**Subject: Bell Cottages-2017-CU-003
PACE Project No. 18235.40.02**

Thank you for the opportunity to complete a review of the proposed cluster housing development Bell Cottages.

SECTION A

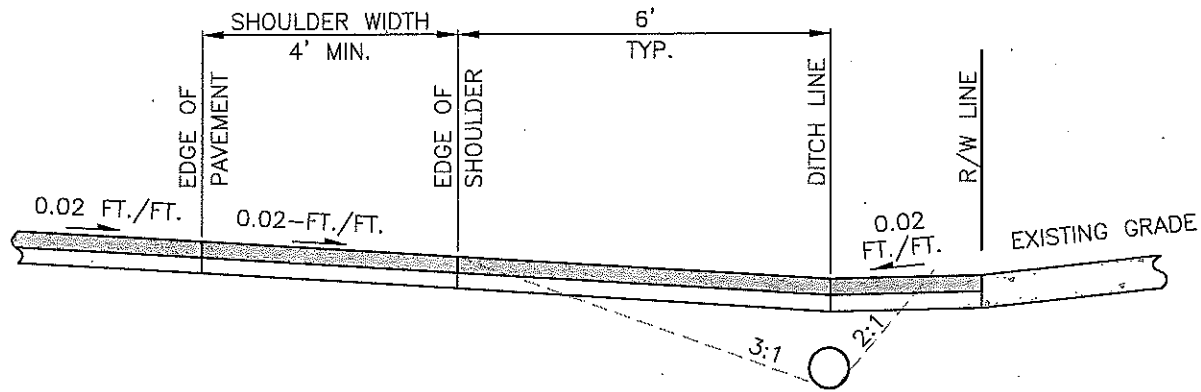
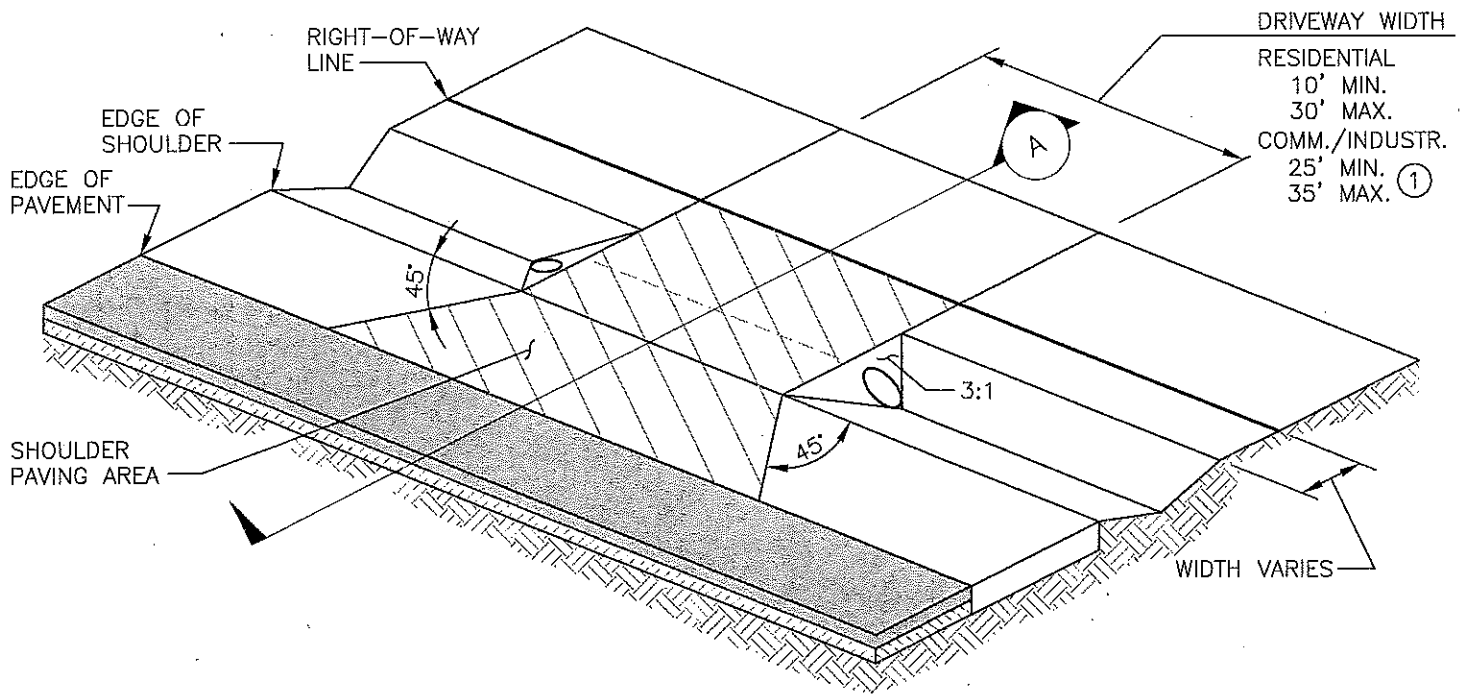
1. While there is currently no guidance for the type/design of the driveway/driveway entrance it is our professional opinion that the development most closely resembles a commercial/multifamily development such as a condo building or a townhome development. As such we would suggest a driveway entrance with a minimum width of 25'. If there were to be no curb and gutter and sidewalk proposed on the project's frontage the driveway approach should meet King County Roadway Standard Figure 3-003 (although there is no ditch in this project). The additional 7' of width vs a joint access tract would be welcomed especially if there are no sidewalk connections from the ROW onto the site.
